RE: **Lot 5 Block 8 Unit 22 Volcano Cliffs SAD 228**
6412 Canavio Pl NW
Engineers Stamp Date 5/24/17 (D10D003E5)
Pad Certification Dated 7/24/17

RE: **Volcano Cliffs Subdivision Lot 5, Block 8, Unit 22**
5412 Canavio Pl NW
Grading and Drainage Plan
Engineers Stamp Date 5/24/17 (D10D003E5)

GRADING & DRAINAGE PLAN
6412 Canavio Place NW
LOT 5, BLOCK 8, UNIT 22 VCS

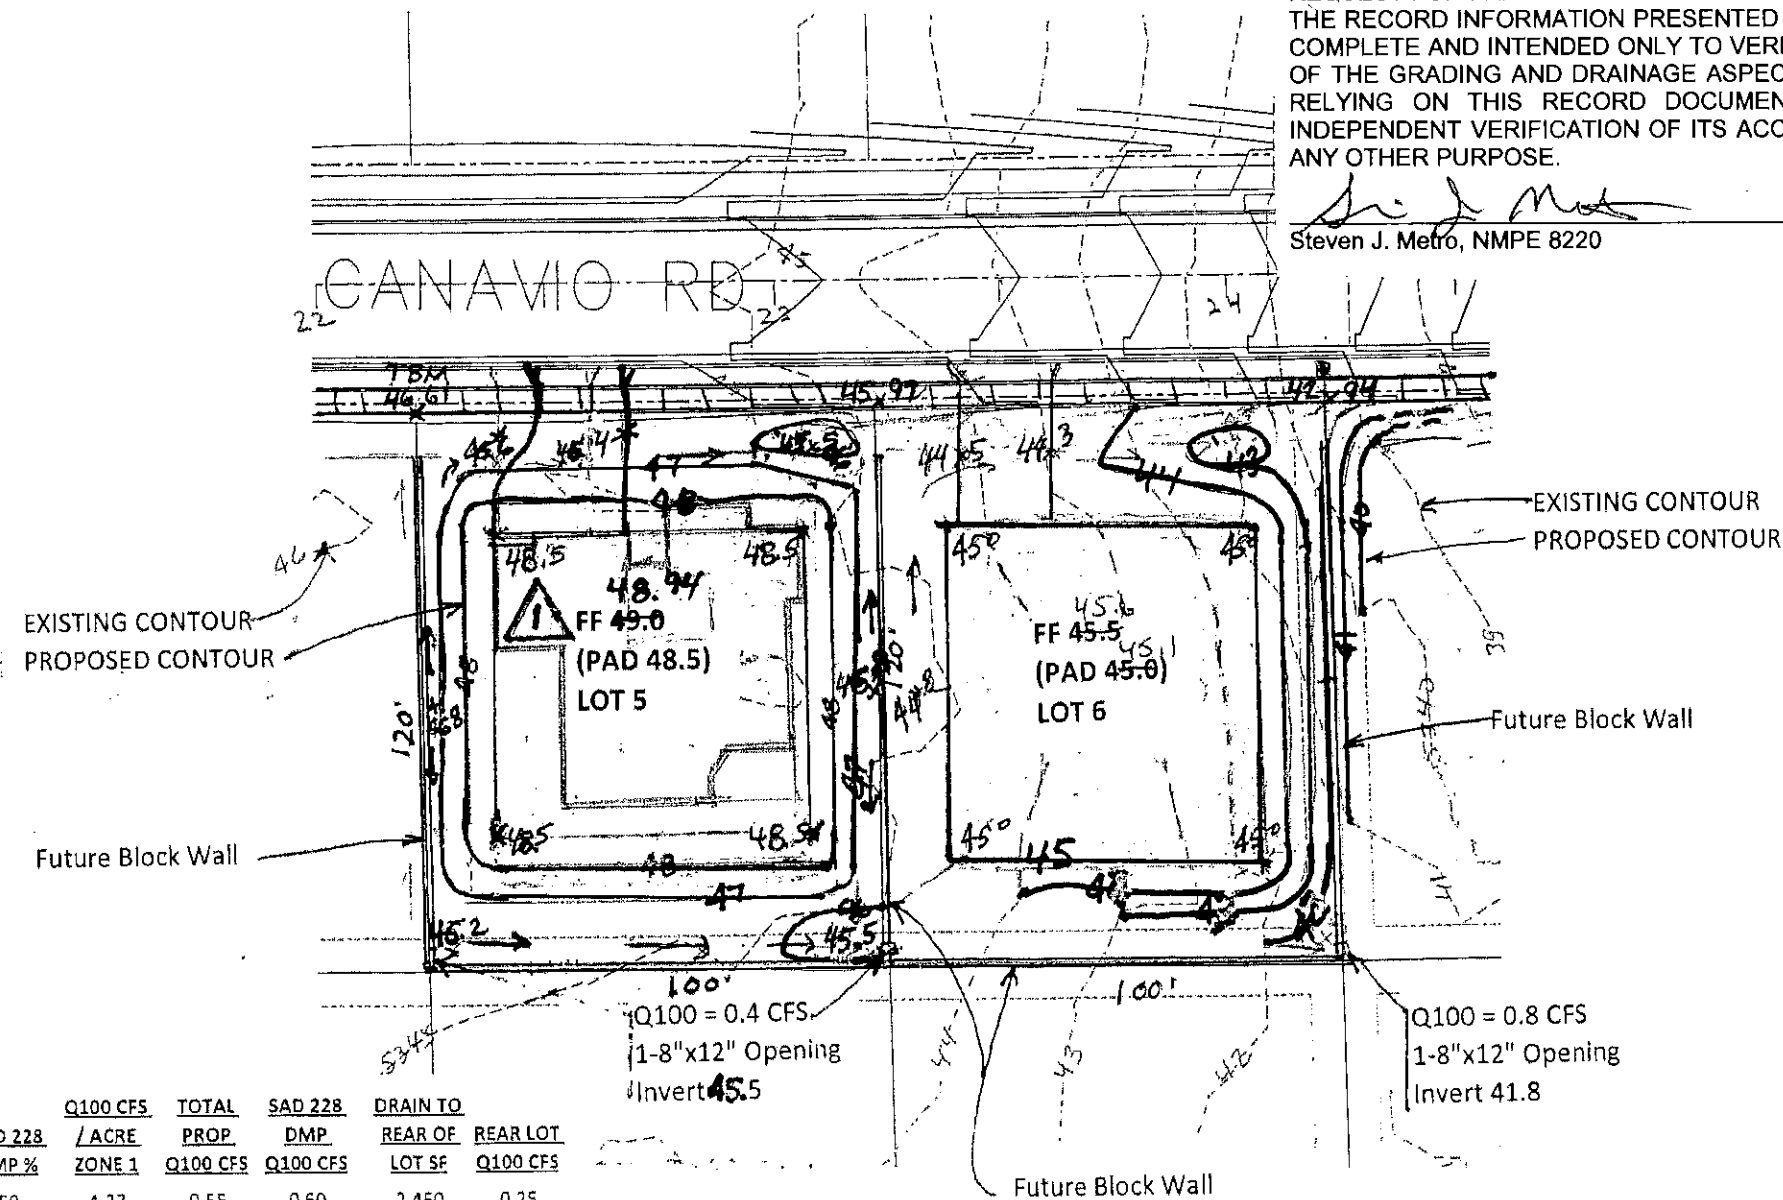
Based upon the information provided in your submittal received 7/27/17, this plan with Pad Certification dated 7/24/17 is approved building permit.

Reiterate to the Owner/Contractor that a separate permit for a garden/retaining wall must be obtained, with the approved G&D plan dated 7/24/17.

Prior to Certificate of Occupancy release, Engineer Certification per the DPM checklist will be required.
